Access Compliance Report

Public Rights-of-Way

Intersection ID: N/A	Main Street: DIXIE_RIVER_RD	Cross Street: INVERNESS_BAY_RD	Location: NW
ADA ID: 126483467D7B	Ramp Type: PerpDiag	Initial Pass/Fail: Fail	Overall Compliance: No
		Severity Score: 10

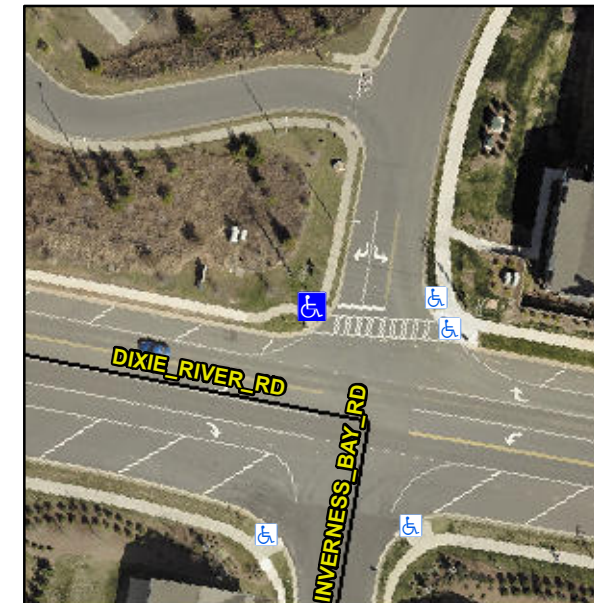
R304.5.1, R304.5.3

Compliance	Description	Data	Compliance	Description	Data
N/A	Ramp Length (in)	42.0	Yes	Ramp Slope (%)	5.5
No	Ramp Width (in)	43.0	No	Ramp XSlope (%)	4.8
N/A	Flare Type LT	N/A	N/A	Flare Type RT	N/A
N/A	Flare Slope LT (%)	N/A	N/A	Flare Slope RT (%)	N/A
N/A	Flare Traversable LT?	N/A	N/A	Flare Traversable RT?	N/A
N/A	Landing Length (in)	N/A	N/A	DWS Provided?	N/A
N/A	Landing Width (in)	N/A	N/A	DWS Contrast?	N/A
N/A	Landing Slope (%)	N/A	N/A	DWS Length (in)	N/A
N/A	Landing X Slope (%)	N/A	N/A	DWS Full Width?	N/A
N/A	Landing Curb? (Y/N)	N/A	N/A	DWS Offset (in)	N/A
N/A	Shared Landing?	N/A			
N/A	Gutter Ponding?	N/A	N/A	Gutter Slope (%)	N/A
N/A	Gutter Lip Ht (in)	N/A	N/A	Gutter X Slope (%)	N/A
N/A	Painted X Walk1?	No	N/A	Painted X Walk2?	Yes
	X Walk 1 Direction	To S		X Walk 2 Direction	To E
N/A	X Walk 1 Width (in)	N/A	N/A	X Walk 2 Width (in)	102.0
	X Walk 1 Slope (%)	0.9		X Walk 2 Slope (%)	0.0
	X Walk 1 X Slope (%)	1.3		X Walk 2 X Slope (%)	3.5

Remove & Replace Curb Ramp With Two New Directional Ramps or Equivalent.
